Project description: Submittal of revised plans to construct four residential units in two above grade structures totaling 11,476 square feet and a 4,340 square foot sub-grade parking structure.

Case number: H-14-034
Project Type: HDRB

PROJECT LOCATION (S): **511 Paseo de Peralta**

CASE # H-14-034

SHEET TITLE
FIRST FLOOR PLAN

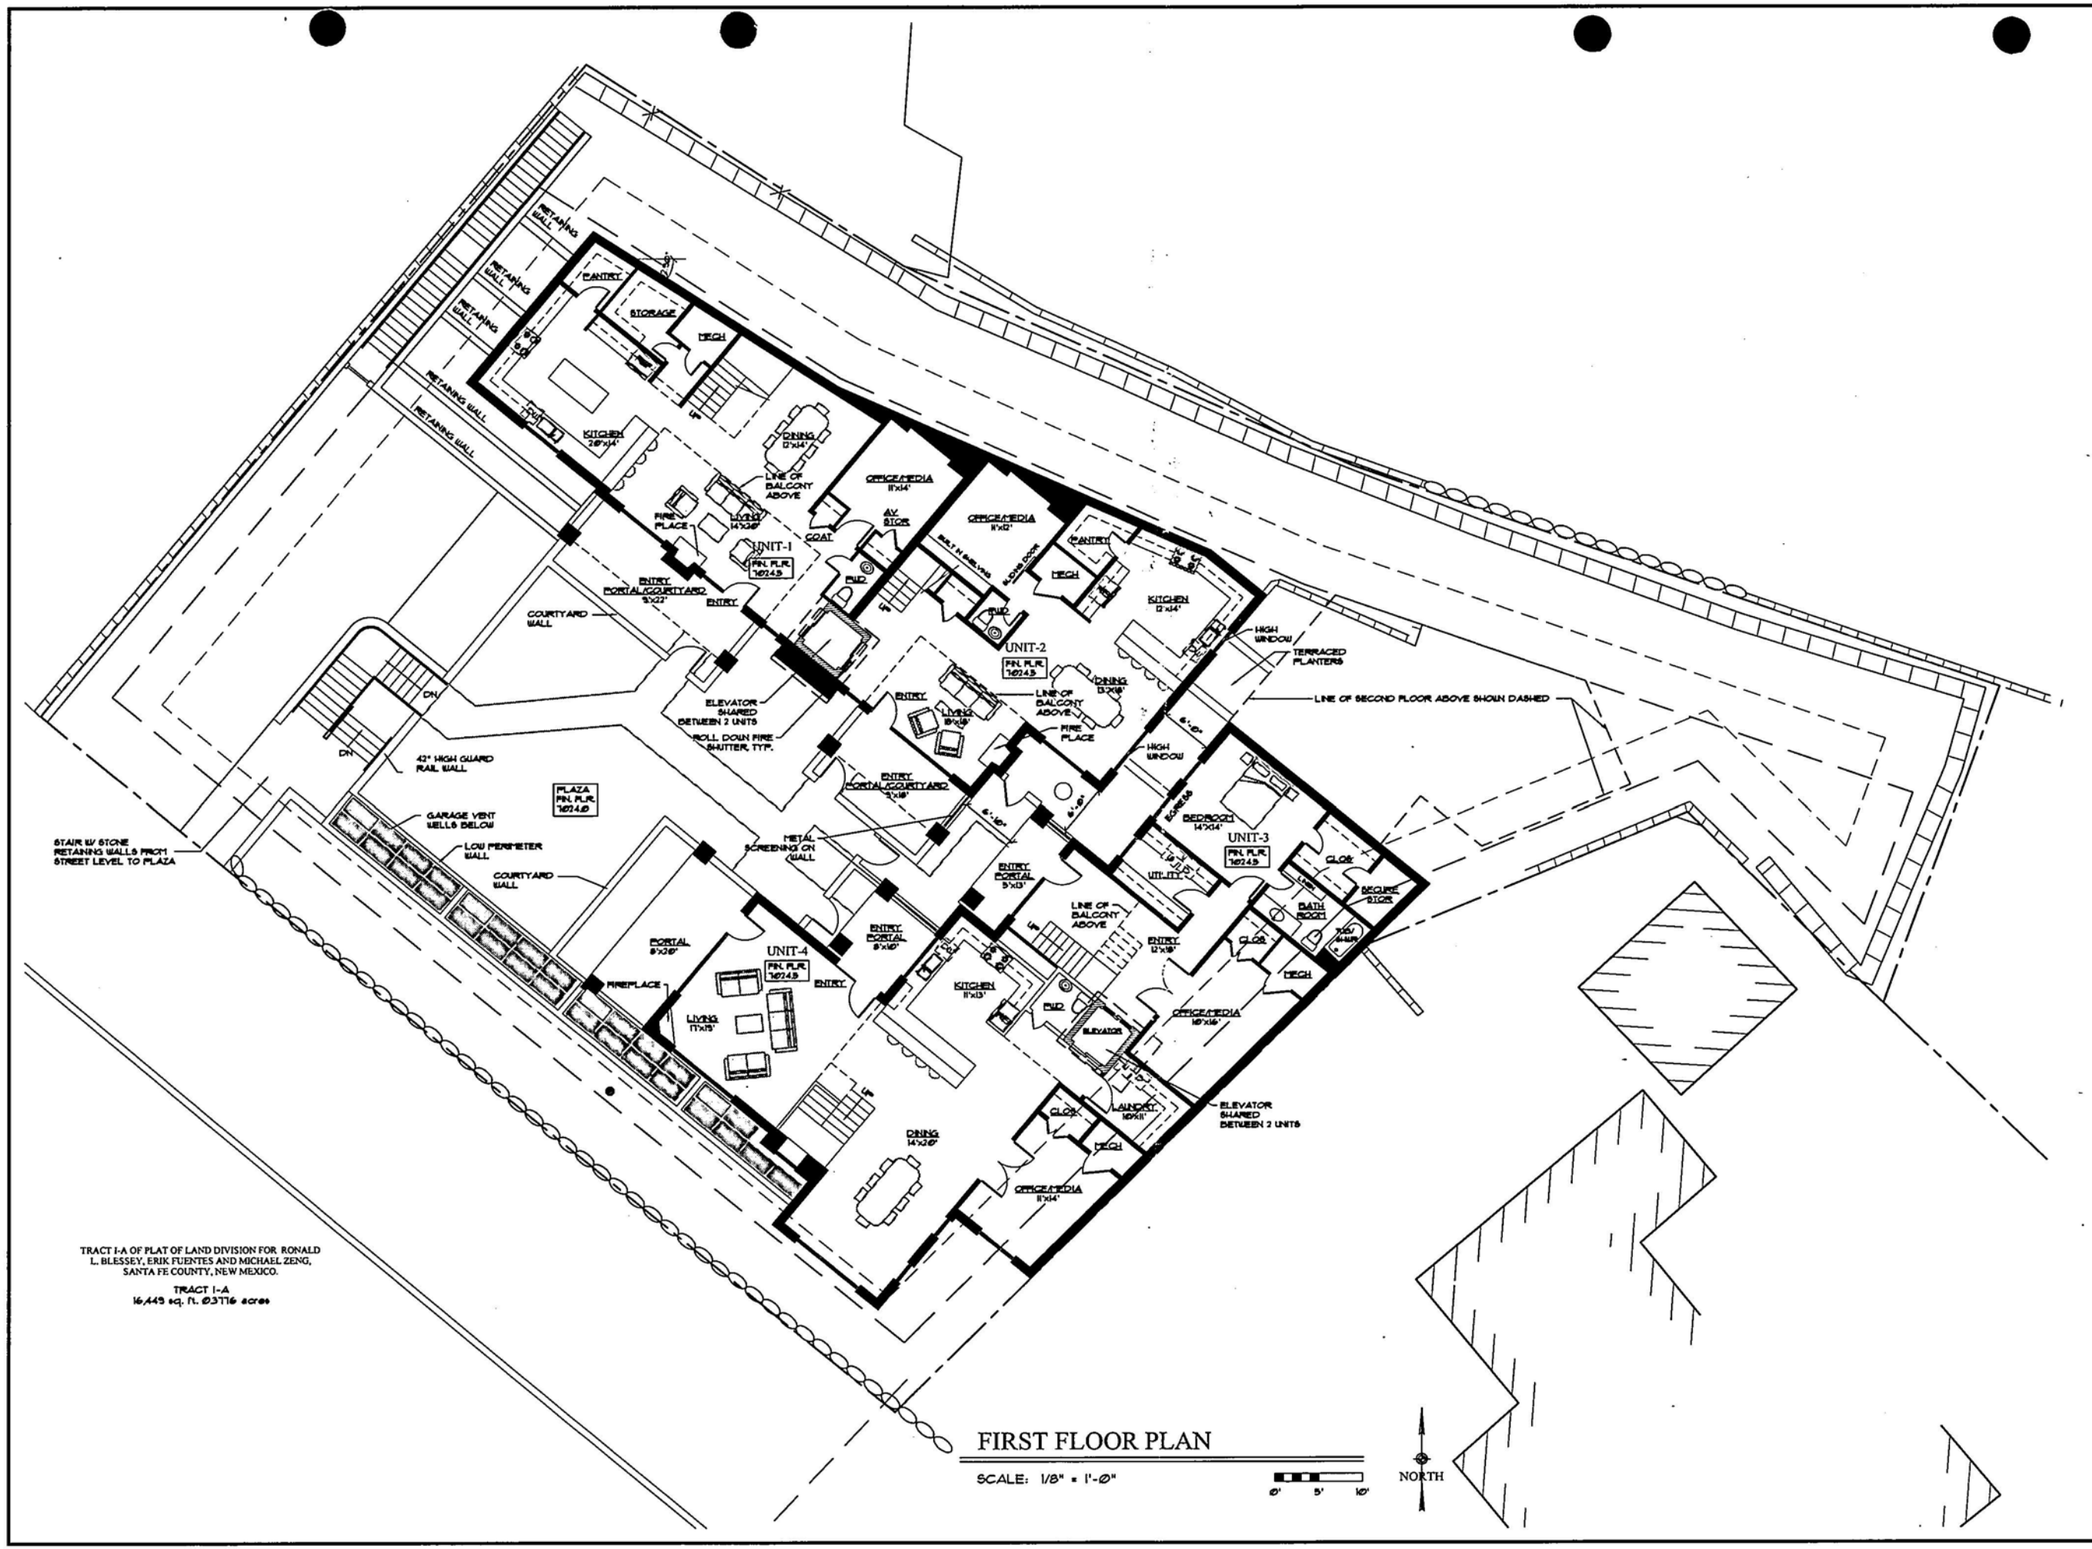
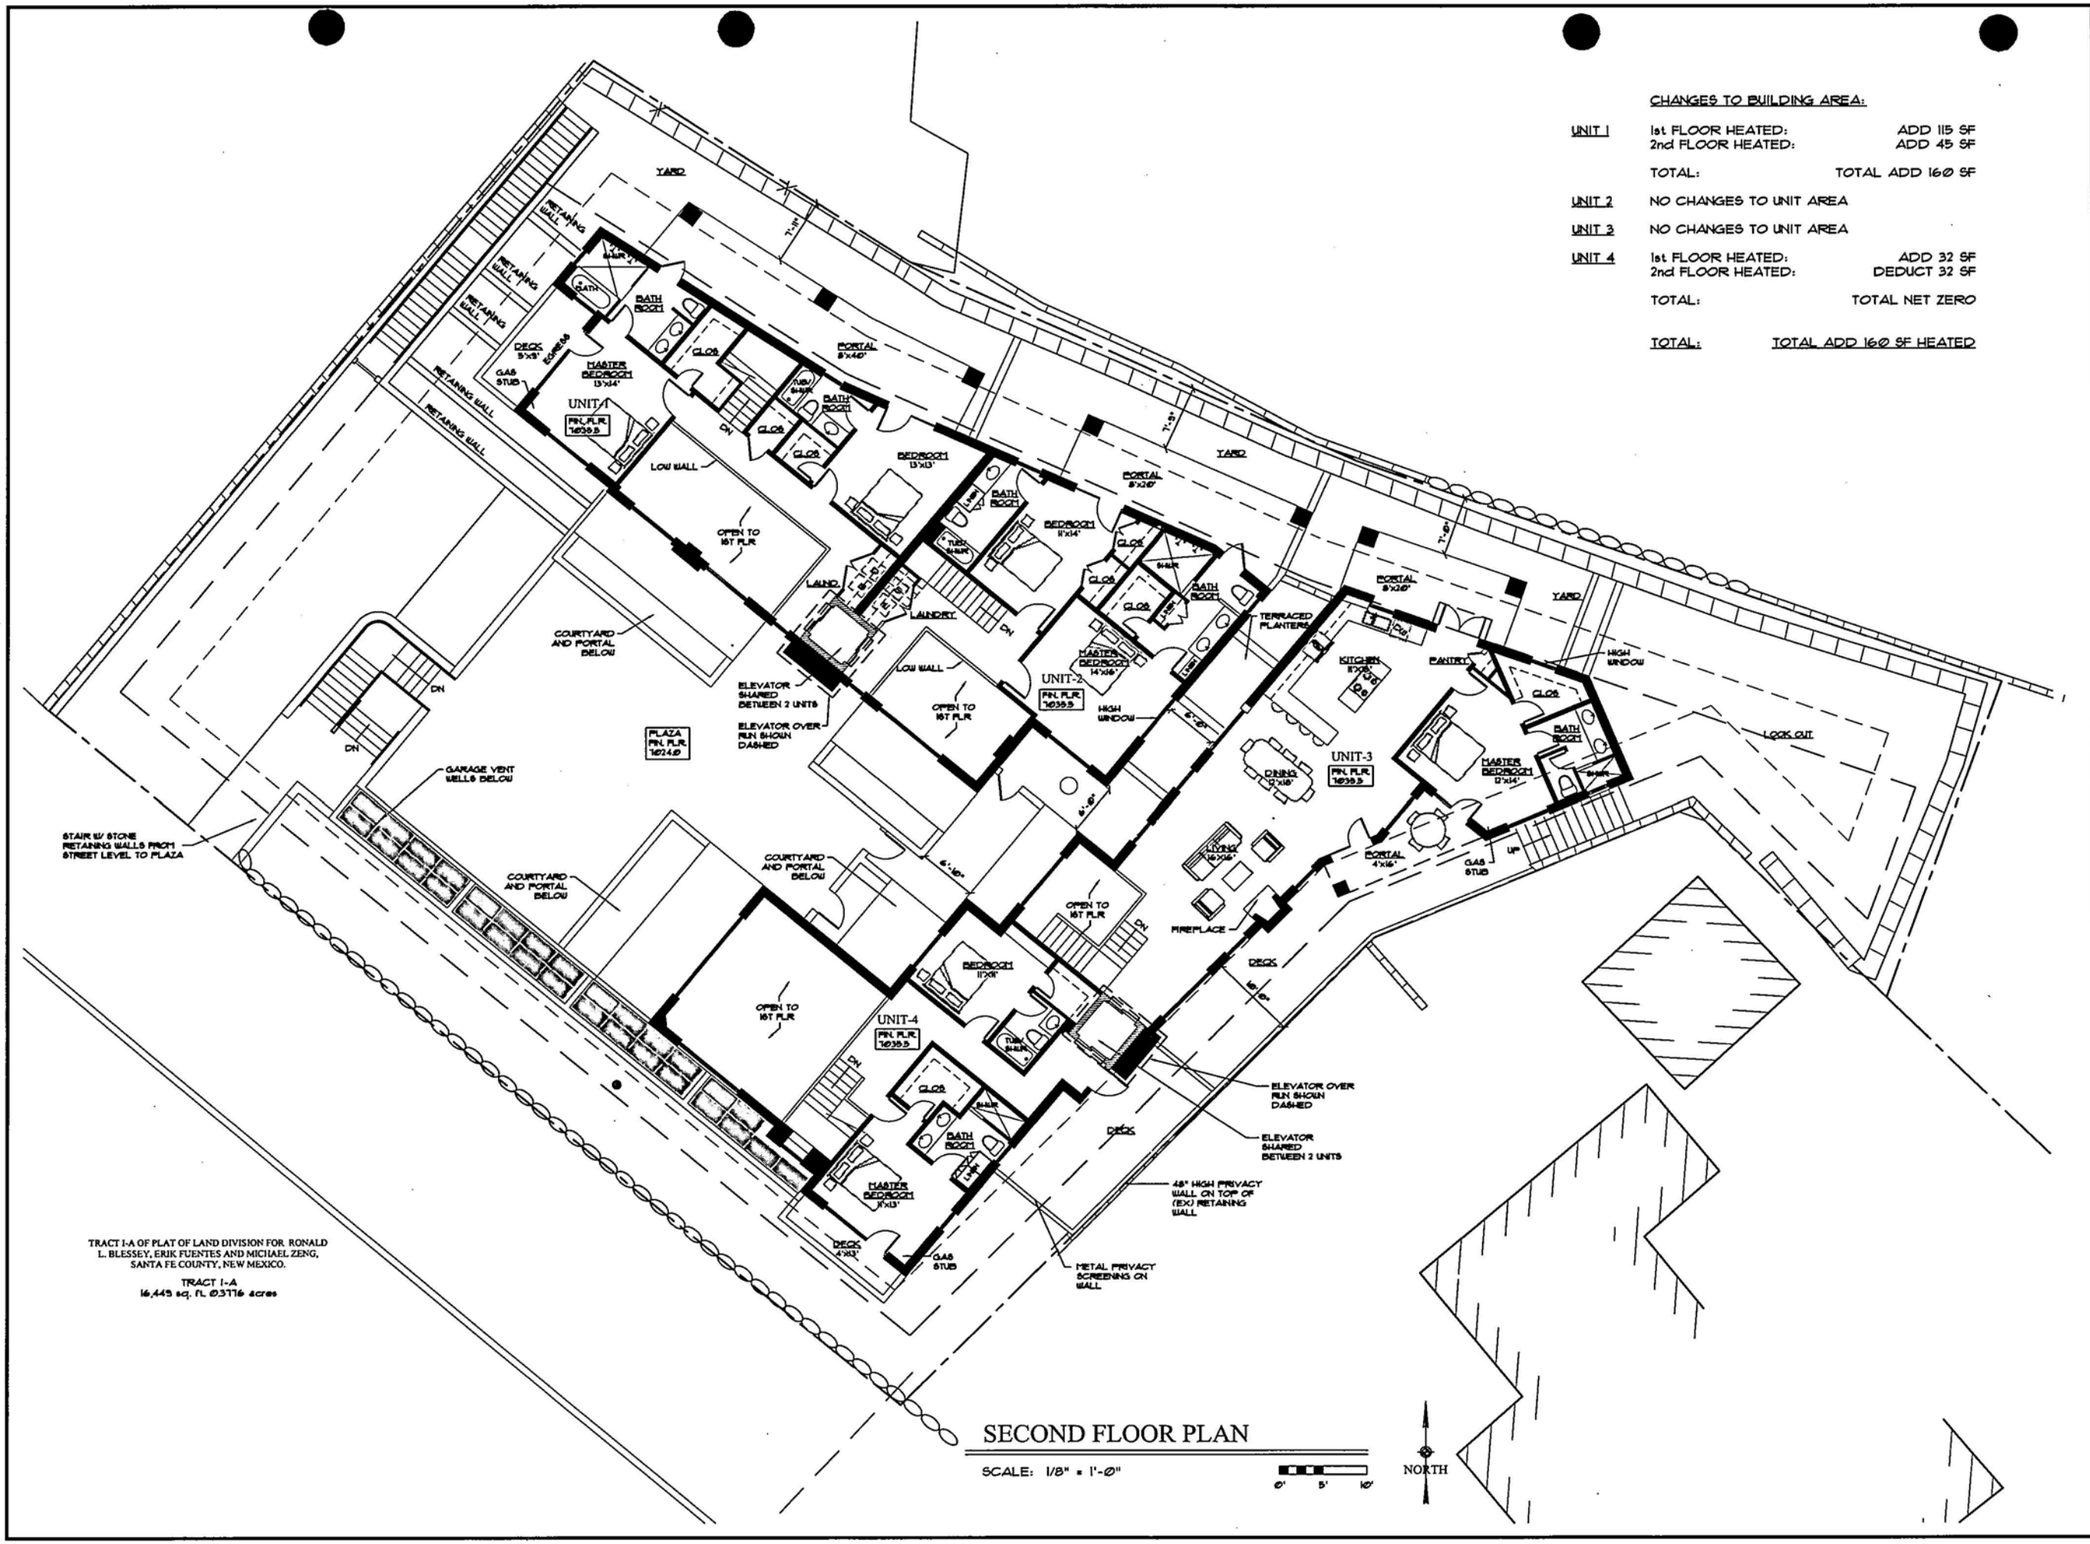
1. The west end of Building 1 has been stepped to break up its massing. A balcony has been added to the second floor off of the Master Bedroom in Unit 1.
2. The width of the elevator over-run on Building 1 has been decreased in size (both width along façade and depth). In addition, the flat roof overhang has been simplified and its height reduced.
3. The southeast corner of Building 2 has been stepped to break up its massing. A balcony has been added to the second floor off of the Master Bedroom in Unit 4.
4. The width of the elevator over-run on Building 4 has been decreased in size (both width along façade and depth). In addition, the flat roof overhang has been simplified and its height reduced.
5. The overhang of the flat roofs has been changed from 30" to 24" measured from the face of the wall to the end of the beams. In addition, the beams have changed from metal to stained wood.

UNIT 1	1st FLOOR HEATED:	ADD 115 SF
	2nd FLOOR HEATED:	ADD 45 SF
	TOTAL:	TOTAL ADD 160 SF
UNIT 2	NO CHANGES TO UNIT AREA	
UNIT 3	NO CHANGES TO UNIT AREA	
UNIT 4	1st FLOOR HEATED:	ADD 32 SF
	2nd FLOOR HEATED:	DEDUCT 32 SF
	TOTAL:	TOTAL NET ZERO
TOTAL:	TOTAL ADD 160 SF HEATED
